SERVICE MANUAL

CD RECEIVER

KD-LX10 KD-LX30

General assembly indication was wrong.
Please change the service manual of
KD-LX10 / KD-LX30.
(Issue No.49537)

General assembly

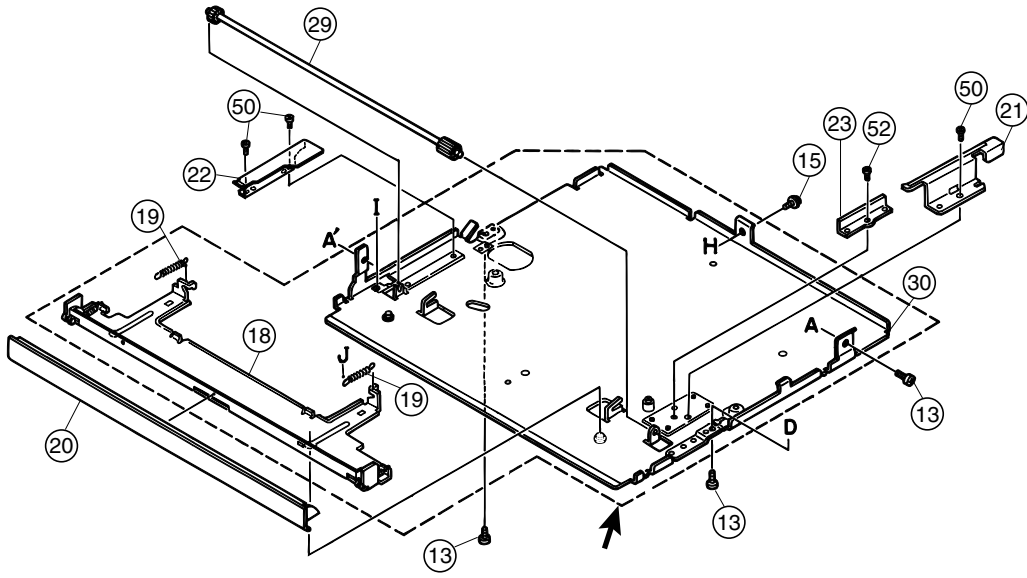
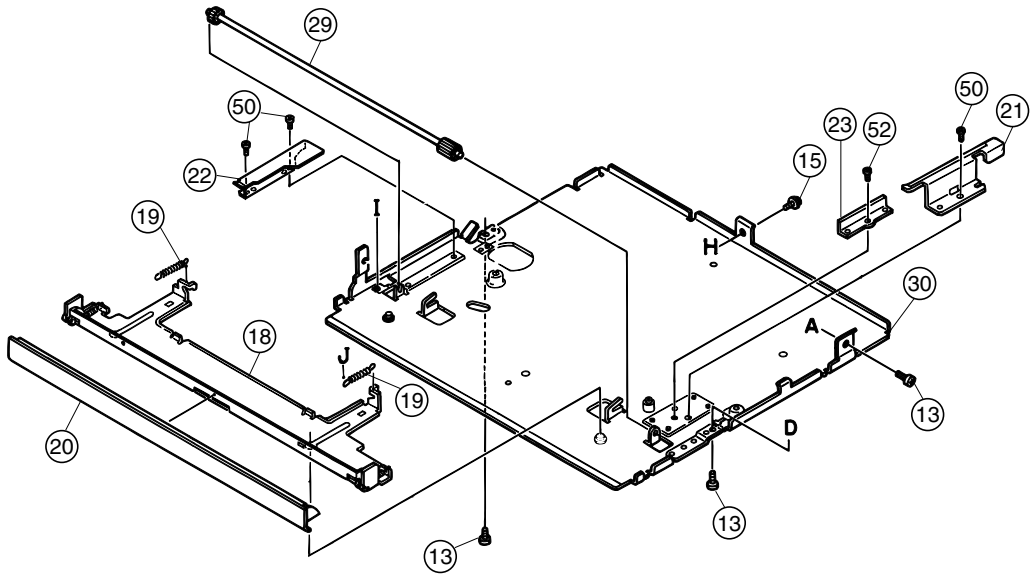
Wrong

Collect
